**AGENDA
FOR THE CITY OF OLIVETTE
PLANNING AND COMMUNITY DESIGN
COMMISSION
MEETING OF NOVEMBER 17, 2016
AT 7:00 P.M.
IN THE OLIVETTE CITY COUNCIL
CHAMBERS
AT CITY HALL GOVERNMENT CENTER
LOCATED AT 9473 OLIVE BOULEVARD**

Petitioner for: Site Plan, Community Design, and Concept Stormwater Management Plan Review

DATE: NOVEMBER 17, 2016
TO: PLANNING AND COMMUNITY DESIGN COMMISSION
FROM: CARLOS TREJO, AICP
DIRECTOR OF PLANNING AND COMMUNITY DEVELOPMENT
RE: 21 STACY DRIVE
PETITION FOR COMMUNITY DESIGN, SITE PLAN, & CONCEPT STORMWATER MANAGEMENT
PLAN REVIEWS

RE: 21 STACY DRIVE
PRELIMINARY STAFF REVIEW OF PETITION FOR COMMUNITY DESIGN, SITE PLAN, AND
CONCEPT STORMWATER MANAGEMENT PLAN REVIEW

Current South Property Line Swale-Street View Looking West

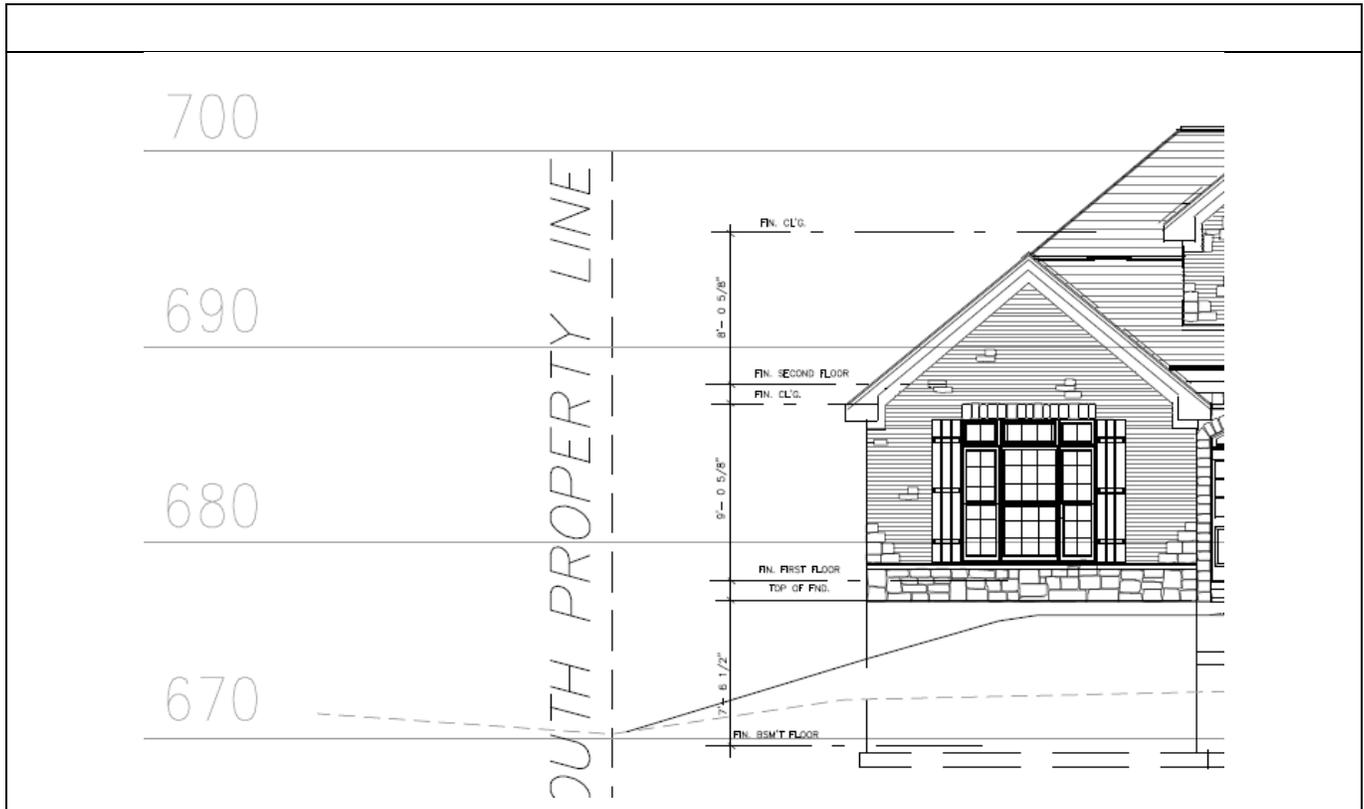
- The floor elevation of the new home will be 5-feet higher than the existing, which may increase the velocity of runoff. Plans illustrate a swale that should be maintained to protect the neighbor to the south.

- Staff and the Petitioners met with neighbors of the property on Friday, November 2, 2016.
- Stormwater concerns were discussed, specifically the swale between the property to the south.
- The concept Stormwater management plan demonstrates the capture of the proposed roof area.
- In trying to maximize the area where Stormwater can flow and penetrate into pervious surface area, the pop-up emitters were shifted to a location that allows for overflow to sheet flow over grass prior to either leaving the site.
- Staff notes the grades have increased which allows for water generated on the off-street parking areas to drain towards the street. While the slopes closer to the neighbor to the south have increased significantly, the existing off-street parking area has been exchanged for a grassy area.

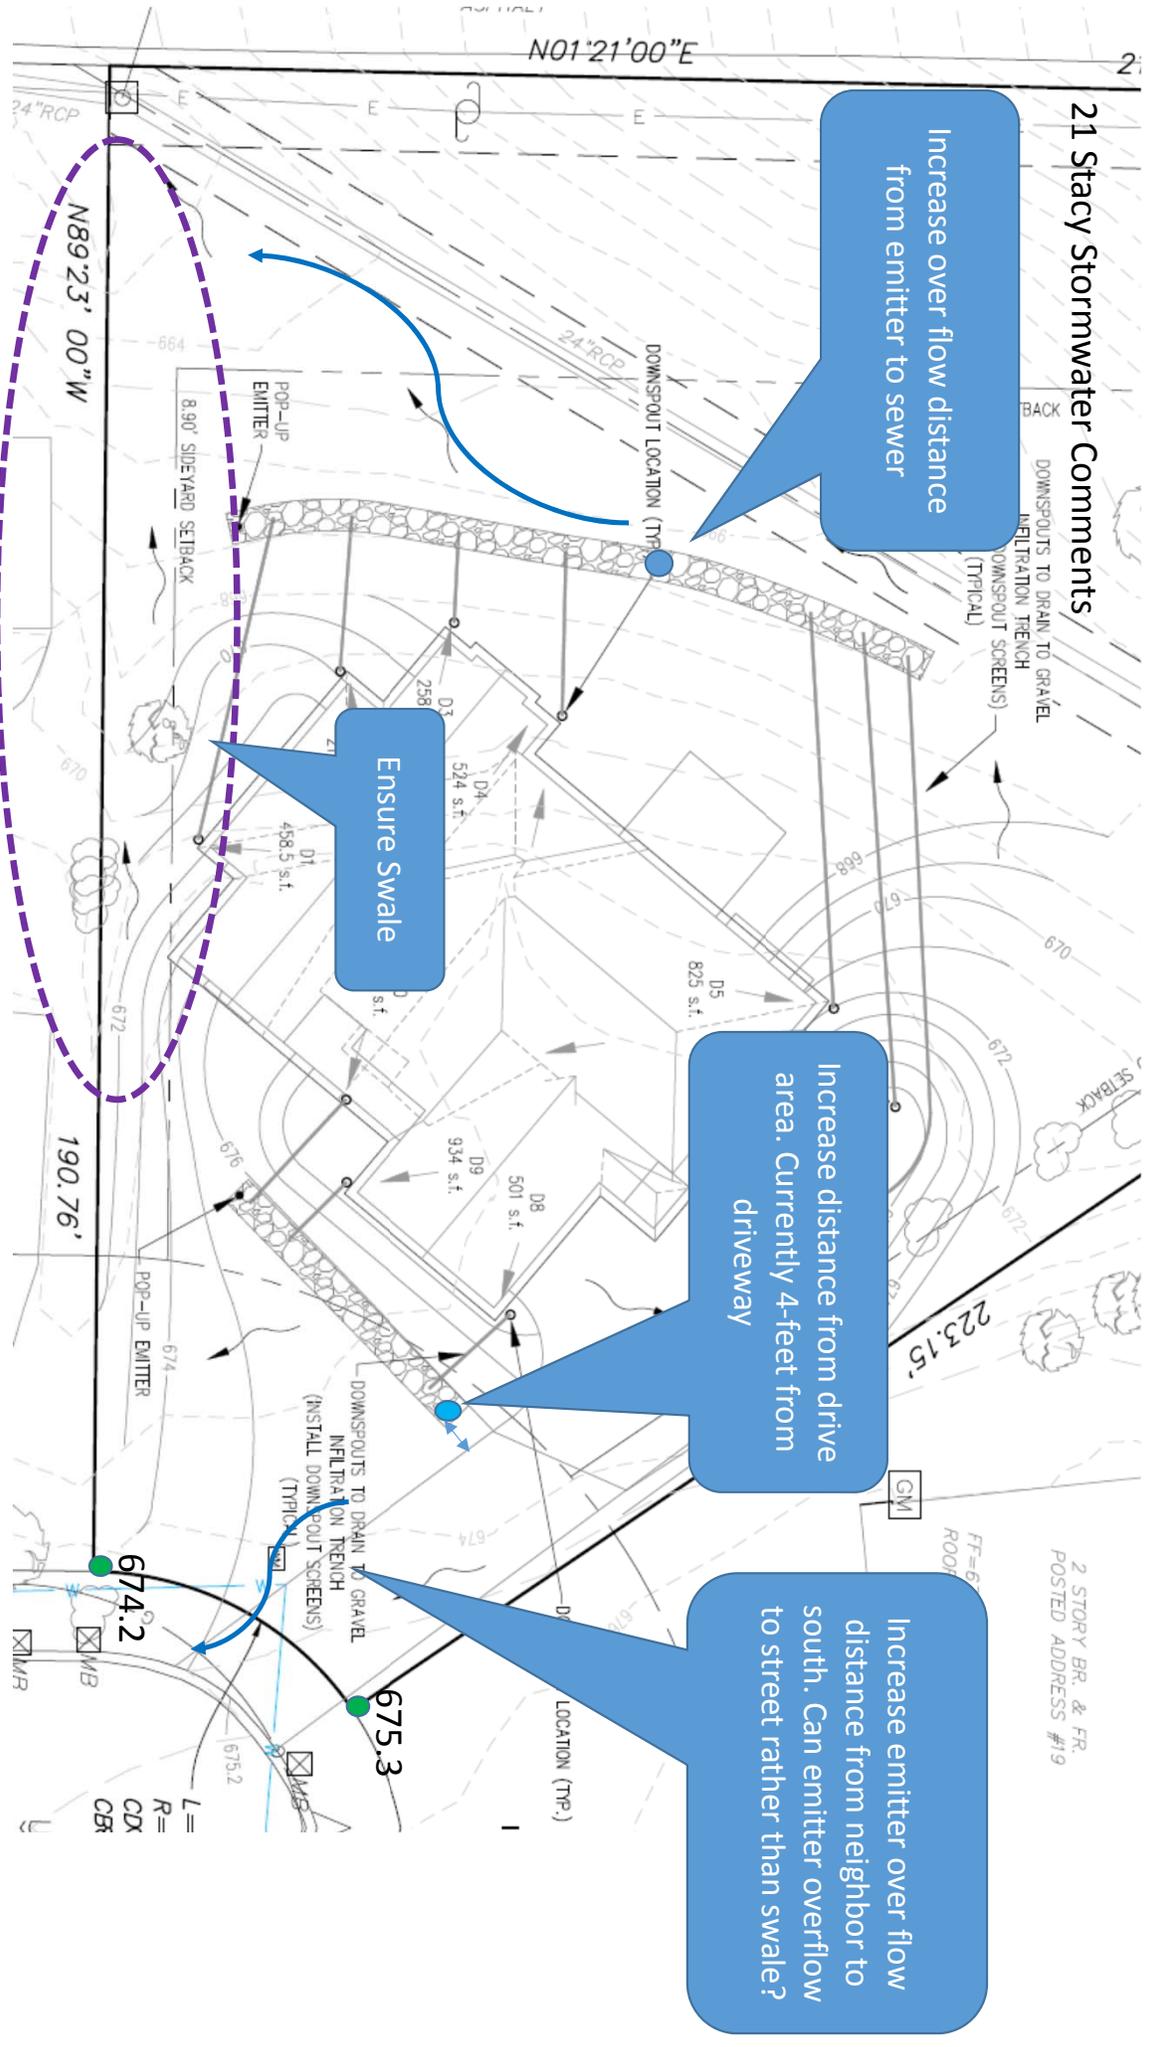
'on low side' please clarify

Increase distance from drive area. Currently 4-feet from driveway

Increase emitter over flow distance from neighbor to south. Can emitter overflow to street rather than swale?

Ensure Swale

EXHIBIT ONE
Stormwater Design - Flat Bottom

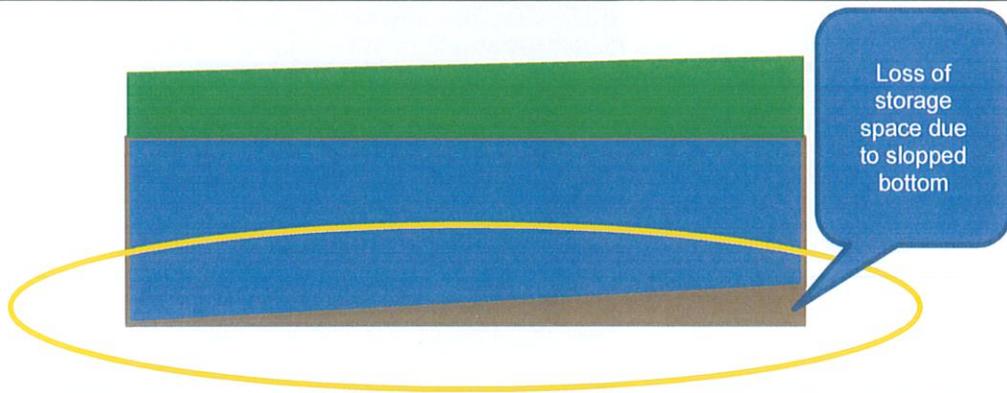
Design. The gravel infiltration trench is proposed to be placed at the northeast to southwest, 120-feet in length. The area stretches over uneven grades ranging from 671 to 665. The 'Gravel Infiltration Trench Detail' on the site plan illustrates a flat bottom and no slope. Stormwater manuals recommend the bottoms of underground detention areas should be flat and should allow even dispersal. Also, sloped bottoms do affect the ability to detain Stormwater. Please review Stormwater design within Exhibit One.

Please provide a scaled site cross section for both proposed Stormwater management areas. Each should reflect the lot conditions. View Exhibit One – 'Stormwater Consultant Comments' for more information.

1. The infiltration trenches on Sheet 4 cross contours which will have a major impact on the storage volume if the trench detail on Sheet 2 is followed. The engineer should draw a profile of both trenches from end to end - showing the surface elevation, the trench bottom elevation and the calculations to confirm that the required storage volume has been achieved.
2. In this case, it is impractical for downspout lines to the infiltration trench to connect to the standpipe. This makes flushing of the downspout pipes impossible without digging them up - so, removing leaves before they get into the downspout lines will be more critical.
3. Stormwater from Downspout D1 should be directed to the infiltration trench rather than discharging on grade.

EXHIBIT TWO Lot Width Measurement & Driveway Encroachment

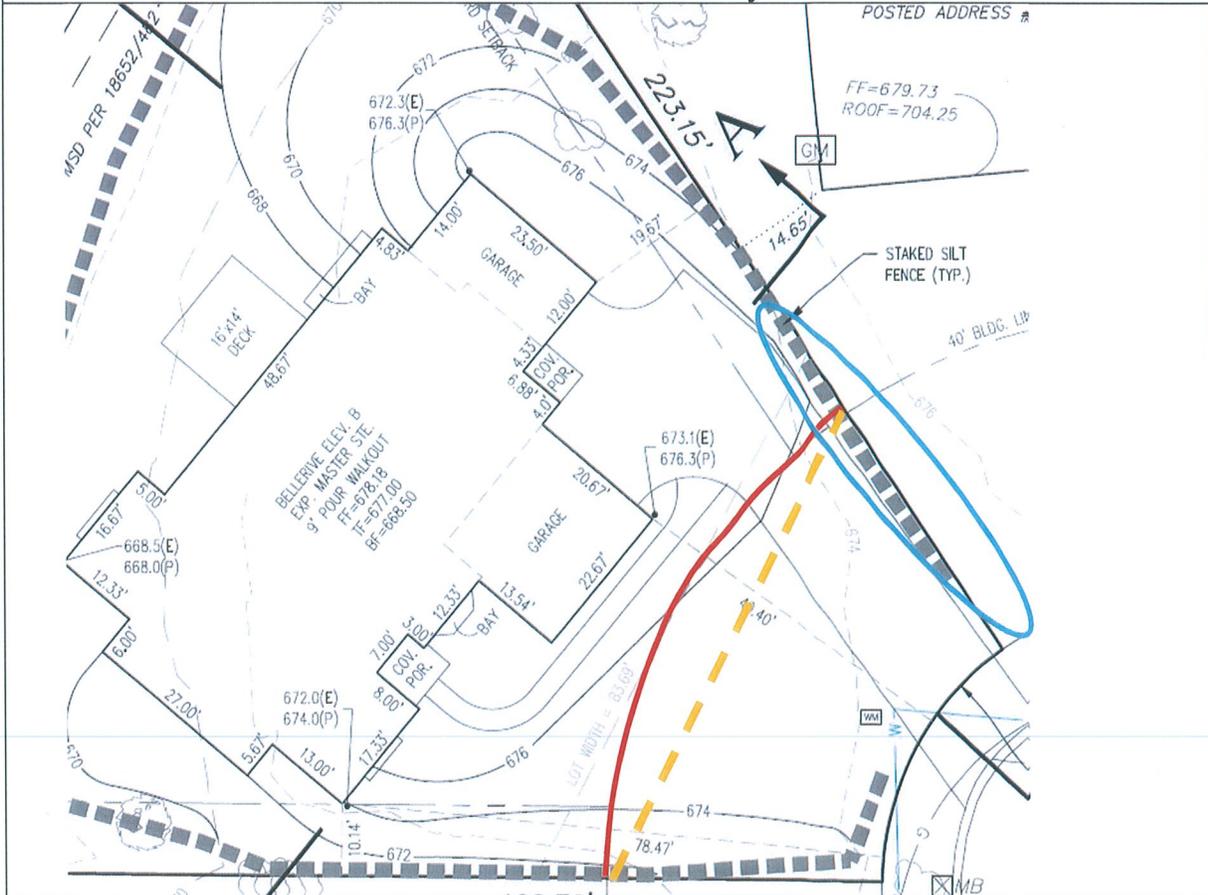
Lot Width. It appears the lot width is incorrectly stated on the site plan. Exhibit Two – Lot Width Measurement and Driveway Encroachment shows an example of the measurement. Update the site plan accordingly for any modifications.
